THE PUBLIC UTILITIES COMMISSION OF OHIO

In the Matter of the Application of The Dayton Power and Light Company for Approval of Its Electric Security Plan)))	Case No. 08-1094-EL-SSO
In the Matter of the Application of The Dayton Power and Light Company for Approval of Revised Tariffs)))	Case No. 08-1095-EL-ATA
In the Matter of the Application of The Dayton Power and Light Company for Approval of Certain Accounting Authority Pursuant to Ohio Rev. Code § 4905.13))))	Case No. 08-1096-EL-AAM
In the Matter of the Application of The Dayton Power and Light Company for Approval of Its Amended Corporate Separation Plan))))	Case No. 08-1097-EL-UNC

Comments of the Staff of the
Public Utilities Commission of Ohio

December 15, 2009

Figure 1: Projected RPM Market Clearing Prices

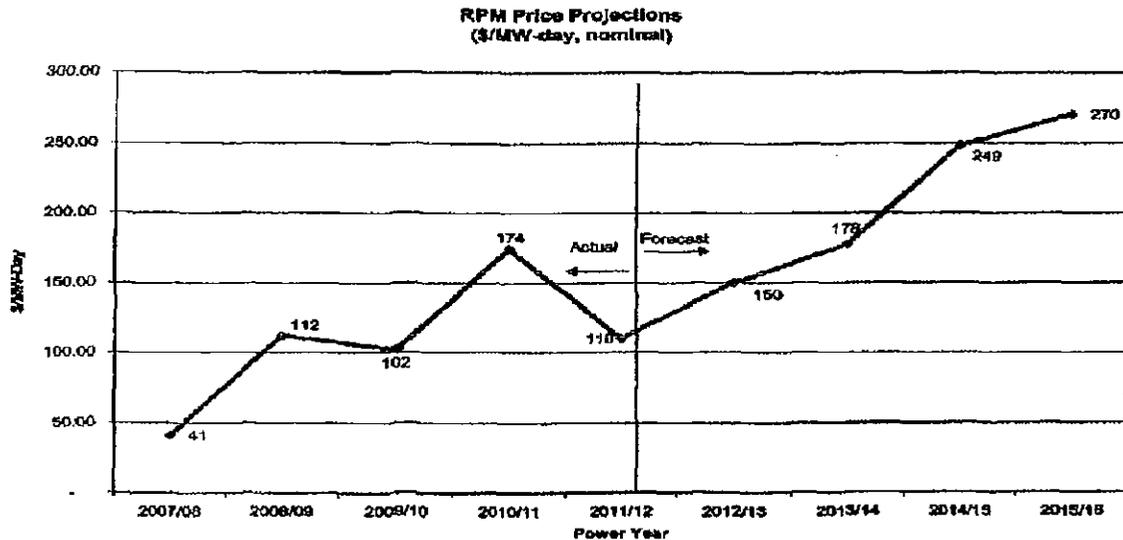
Figure 1 below is taken from the direct testimony of Scott W. Niemann of Charles River Associates. Ms. Marrinan’s valuation² approximately tracks the values in Figure 1. They are interpolated to accommodate the need for annual values however the trend line of values used to calculate the value of avoided capacity tracks the graphed values. For example, the calculations of benefits associated with AMI dependent CCEM programs and 3rd party curtailment made by witness Kevin Hall are based upon the valuation data adopted by Ms. Marrinan and represented in Figure 1.³

The “actual vs. projected” cutoff line was arguably properly drawn for the original filing of this case. On August 4, 2009 the filing was revised however the chart was not updated to account for more recent information. In the interim another Base Residual Auction (BRA) was held by PJM.

The company’s valuation of 2012/2013 capacity exceeds the actual by a factor of almost 10. Due to the severity of price decline in 2011/2012 and given the apparent ongoing supply and demand balance in PJM, subsequent years’ projections are also suspect. The results of the 2011/2012 BRA were known at the time of the revised filings in this case, and the prices used to value capacity should have been also revised.

These inflated capacity values tend to overstate customer benefits associated with demand reduction. Staff believes the revisions will reduce the value of programs by reducing the value of avoided capacity. We recommend the company revise its estimates and recalculate the benefits accordingly.
